**From:** Natalie Yuhas <n.yuhas216@gmail.com>  
**Sent:** Wednesday, July 3, 2024 3:45 PM  
**To:** Planning Commission  
**Subject:** Case No. 2023-676 Hearing

Re: *Preliminary Subdivision Plat request for Canterbury Crossing*

Responding to the Preliminary Subdivision Request submitted by Prestige Builder Group for the July 8, 2024 Hudson Planning Commission meeting, we generally agree with many of the comments contained within the Staff Report, with certain initial exceptions:

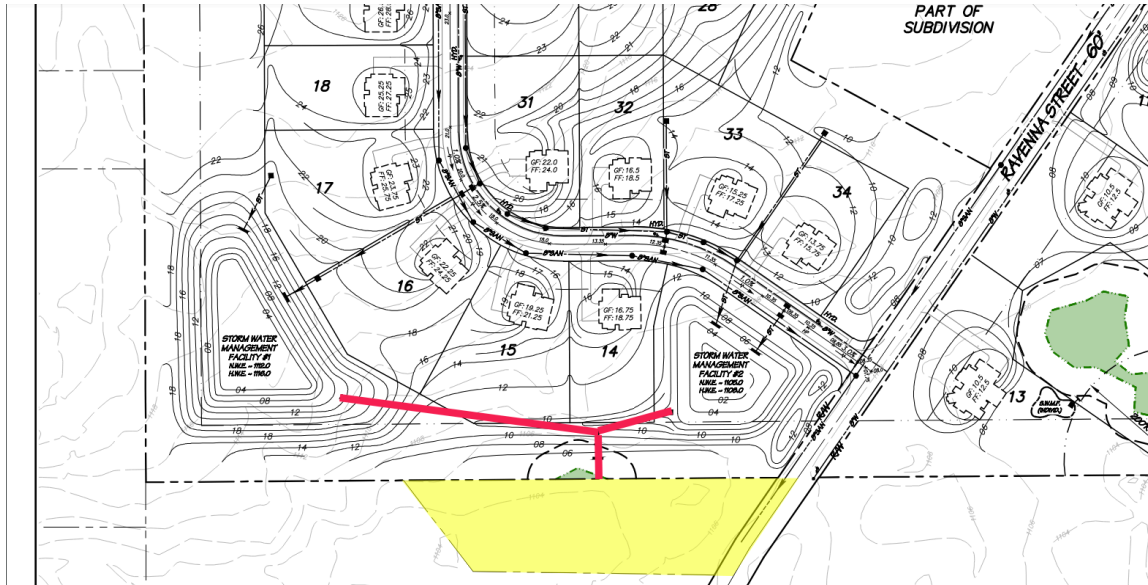
Now, let's discuss stormwater management. If you observe the grading elevations on page 3 of the applicant's site plan (labeled "Utility Plan") you will note that should the ponds ever reach capacity, any water that spills over the banks will travel directly towards my property. This is in direct conflict with Section 1419.05 which requires that major flood paths "... *prevent loss of property or life*".

If you follow the grading lines carefully you will actually find a continuous downward slope from Units 14, 15, 16, 17, 18, 19, 28, 29, 30, 31, 32, 33, and 34 directly towards my dwelling. There is no mounding, no screening, no swales... just lot's of runoff directed at me.

More insultingly, if you zoom all the way to 100%, you will see two pipes leaving Stormwater Management Facility #1 and #2 and converging on my property. The applicant is proposing that you permit them to discharge their stormwater ponds directly onto my property. This is in conflict with Section 660.22 which states that no person shall "... *divert any water or drainage from adjacent lands to or upon any adjacent real property*". I have no agreement with the applicant or the City, and will not permit the discharge of stormwater onto, or through, my property. Who would even maintain the discharges in such a ludicrous proposal - there are no easements.

**Stormwater Management: Alternate Proposal**

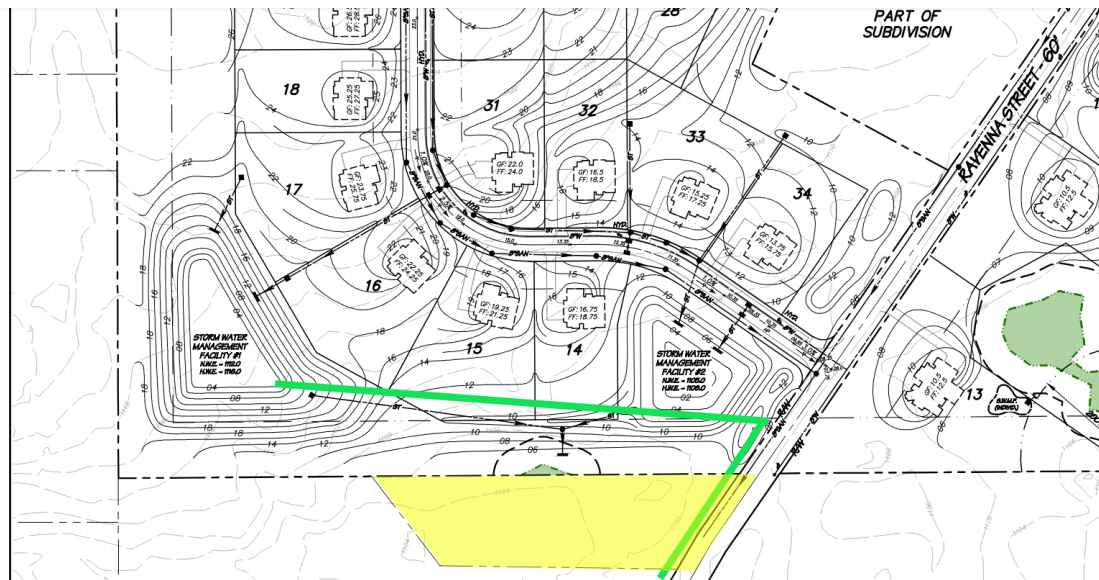
A city owned stormwater pond is located less than 500 feet west of the project. I propose that adequate mounding should be used on the western border to create both visual screening and a flood swale. Stormwater Management Facilities #1 and #2 should outflow towards Ravenna Street, and then be piped via the right-of-way to the City owned stormwater pond. The City's Engineering Report states almost exactly the same under General Comment (4)(a).

Piping the water will be critical, it cannot be allowed to flow on the surface as the right-of-way has a higher elevation than my front yard and any water discharged at street level will simply flow back towards my dwelling.

Elevation	2243 Ravenna St.	S.W.M.F. #2	C.C. Unit 14
1118			
1116			
1114			
1112			
1110			
1108			
1106			
1104			
1102			
1100			
1098

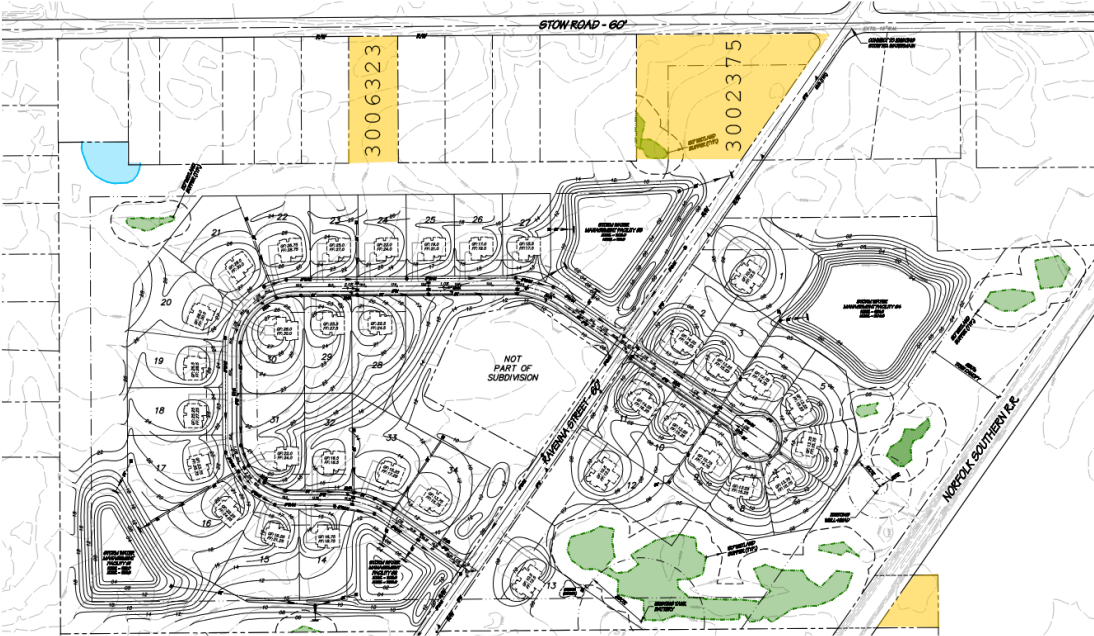
My dwelling is a split-level, a construction style that features significant portions of the living space below ground level. Ground level for my home is 1,106 feet above sea level and the applicant seeks to store tens of thousands of cubic feet of water mere feet from my foundation walls, between altitudes of 1,102 and 1,108. Hundreds of thousands of gallons of water, stored

at or below my finished floor height. It's not a question of if that water will find its way into my home, it's a question of how soon. This creates a very real and imminent danger to me, my family, and our property.

To illustrate the danger this pond poses to my dwelling, I have included a profile illustration of the elevations. Note how the design of new units sit at or above the high water mark, with little regard for existing residential units:

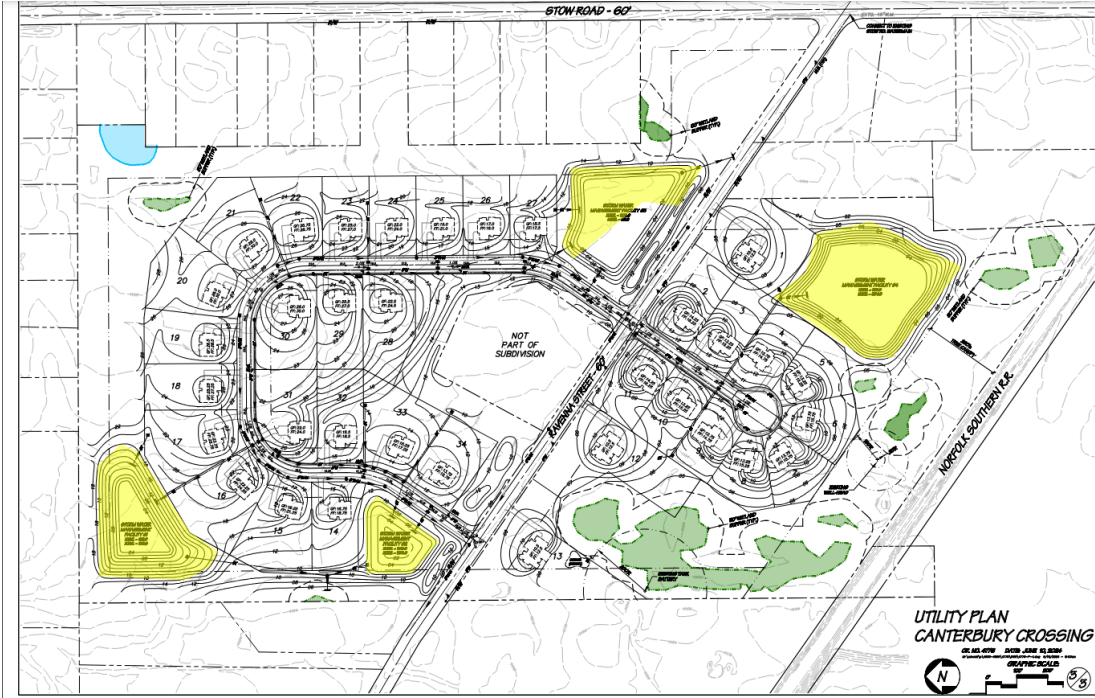
Net density as defined in 1201.07(F)(2) is *".. the measure of dwelling units permitted per acre of land area **contained in the development**, excluding streets, easements, public open space, **land under water**, and certified wetlands and floodplains"*. The 5.61 acres contained in parcels 3002375 and 3006323 are clearly not "contained in the development" as illustrated in yellow on the graphic below. No development activity will take place on either of these parcels. In fact, the applicant even uses a similar argument to explain why 0.48 acres of land on parcel 3001397 is excluded from the project. Shouldn't the same reasoning apply to the entirety of parcels 3002375 and 3006323?

Additionally, the applicant has failed to include new or enlarged stormwater ponds as “land under water”. These new ponds are illustrated in blue on the applicants site plan, and labeled Stormwater Management Facilities #1, #2, #3, and #4. While an exact area was not provided on any drawing that I could find, I think a reasonable estimate is 3 acres on the north, and 2 acres on the south.
